2023 Sewer Main Replacement Project 3  
Solicitation Number: CO-00724  
Job No.: 23-4519

**ADDENDUM 1**  
**April 16, 2024**

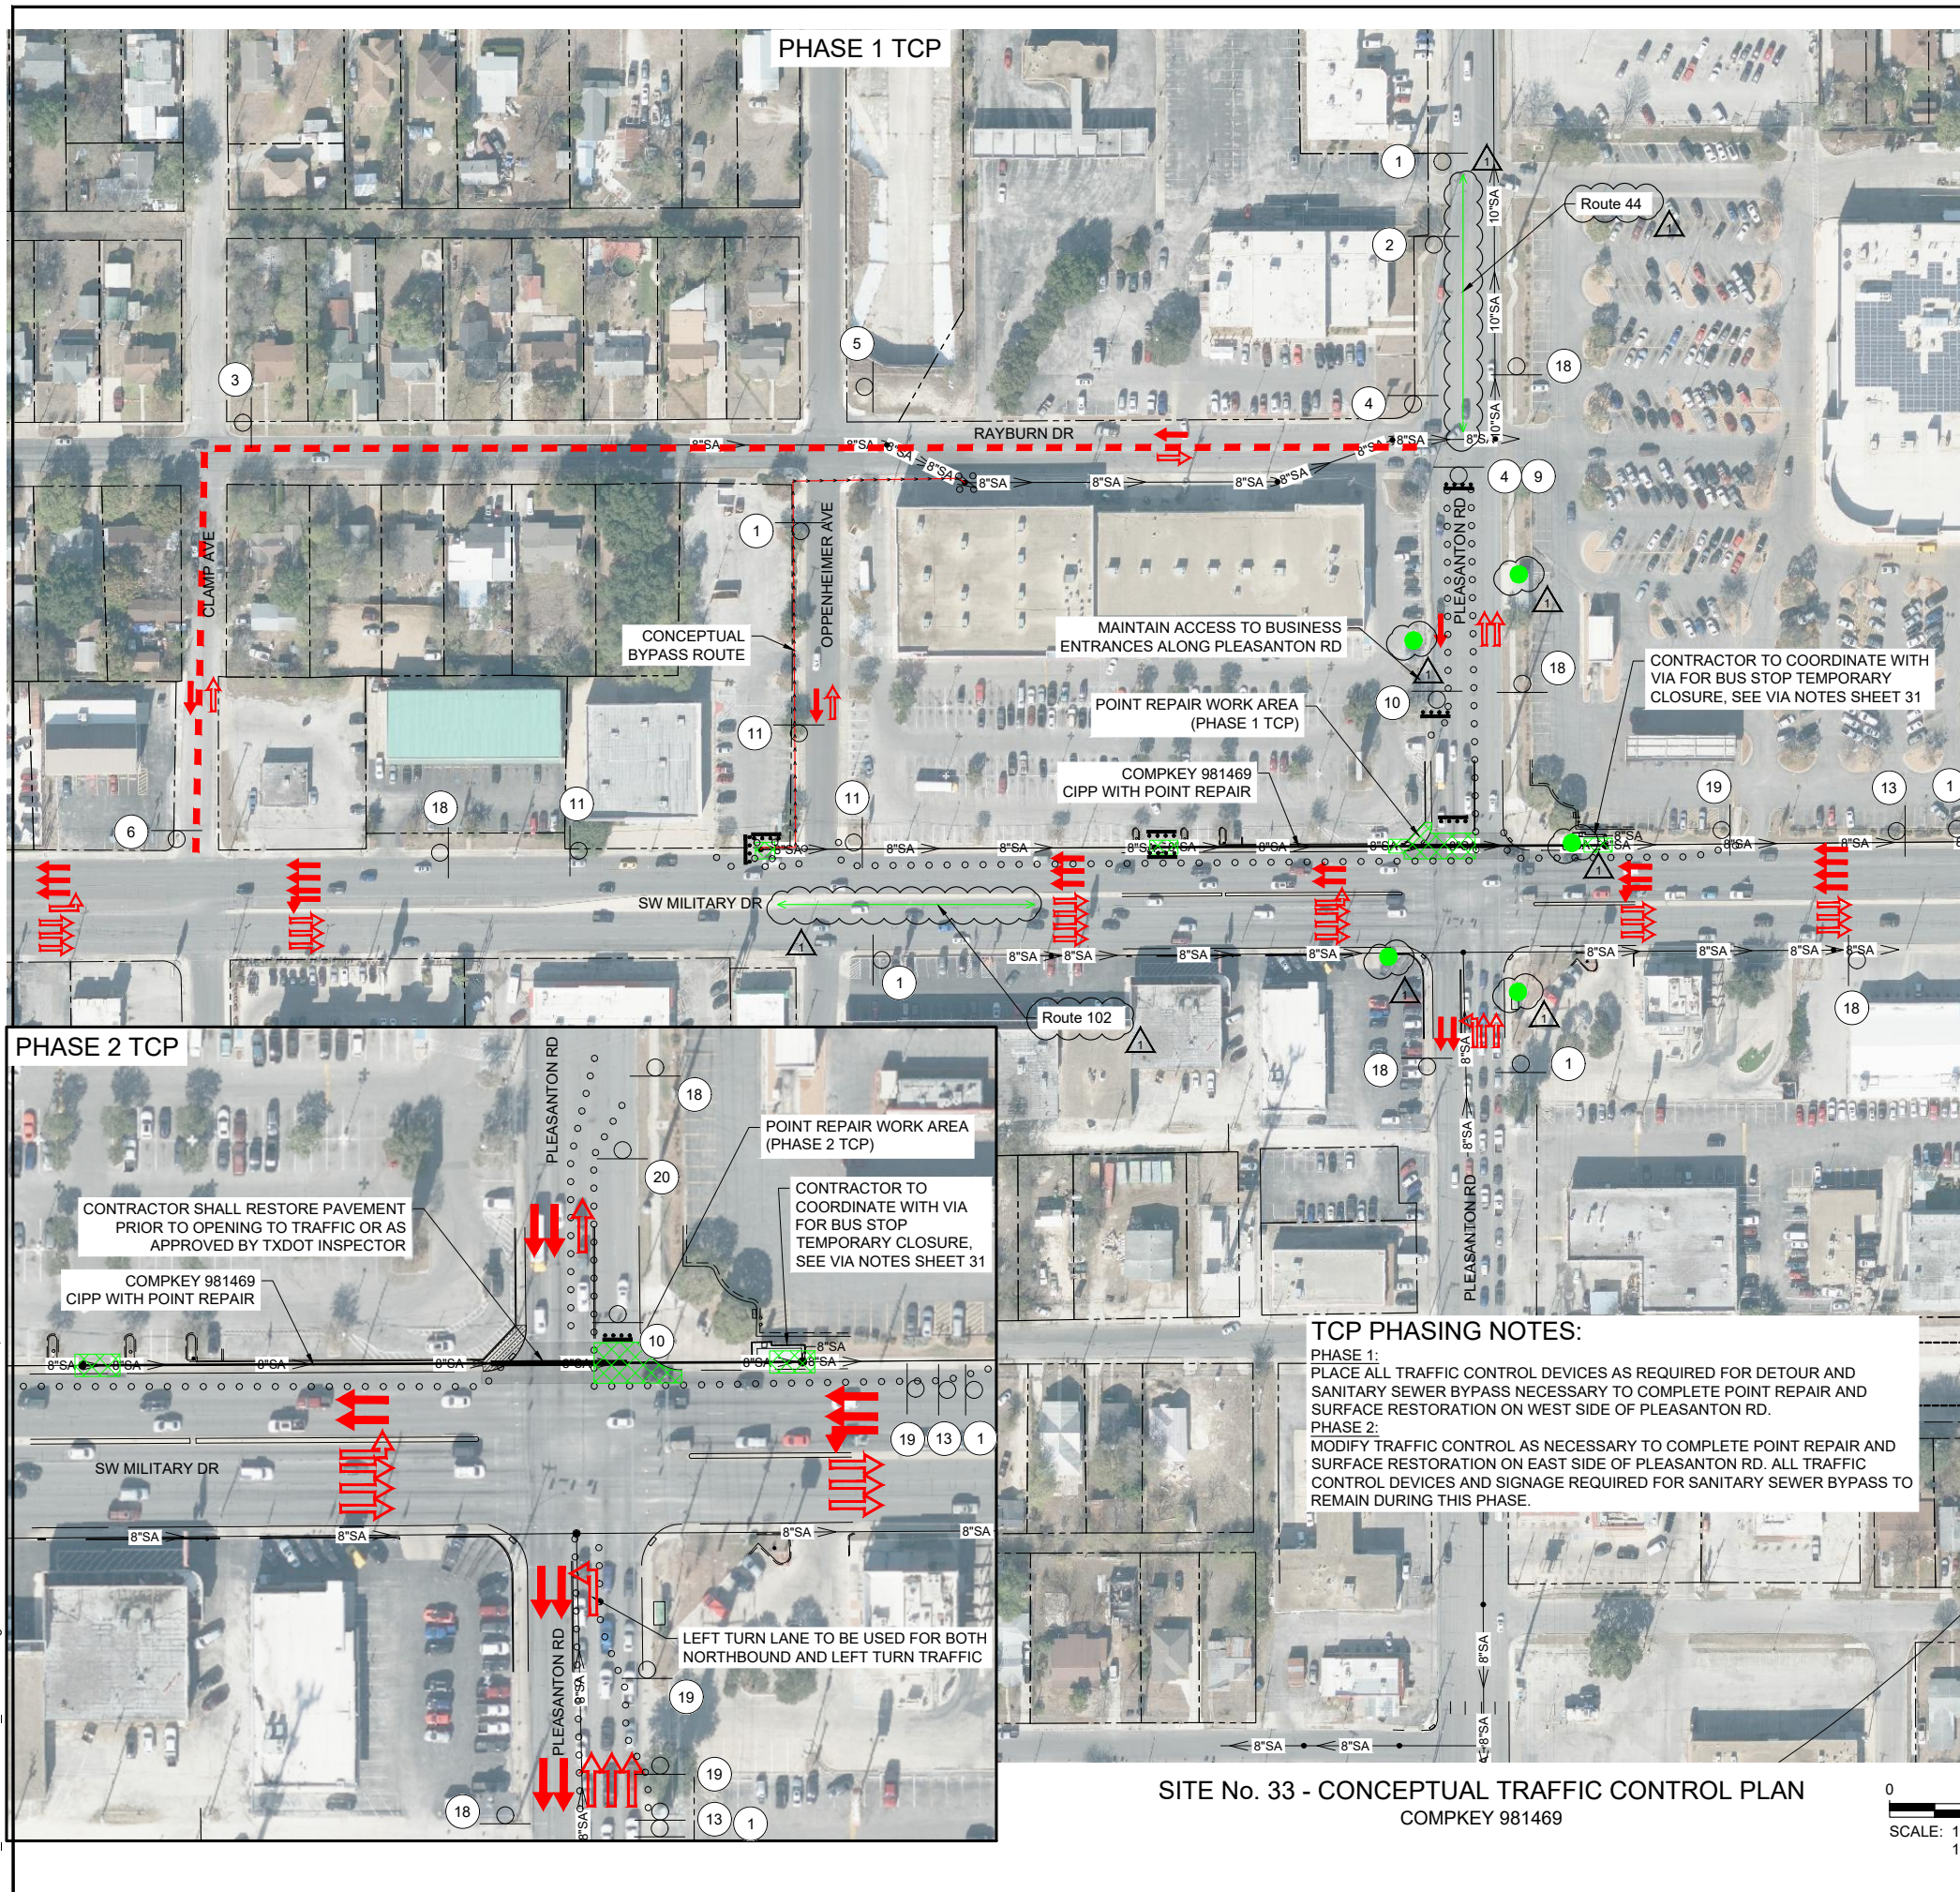
- Site No. 5 – Conceptual Traffic Control Plan Buena Vista St – Sheet 30
  - Updated VIA Notes
- Site No. 33 – Compkey 981469 SW Military Dr CIPP Plan – Sheet 31

- Updated VIA Notes
- Site No. 33 – Conceptual Traffic Control Plan SW Military Dr – Sheet 33
  - Added VIA Bus Stop Locations and added symbol to the Legend

- PROJECT SITE IS WITHIN VIA METROPOLITAN BUS ROUTE 102 ON SW MILITARY DR. CONTRACTOR TO COORDINATE WITH VIA TRANSIT PRIOR TO CONSTRUCTION FOR VIA BUS ROUTE COORDINATION AND TRAFFIC CONTROL. SEE VIA NOTES, THIS SHEET.
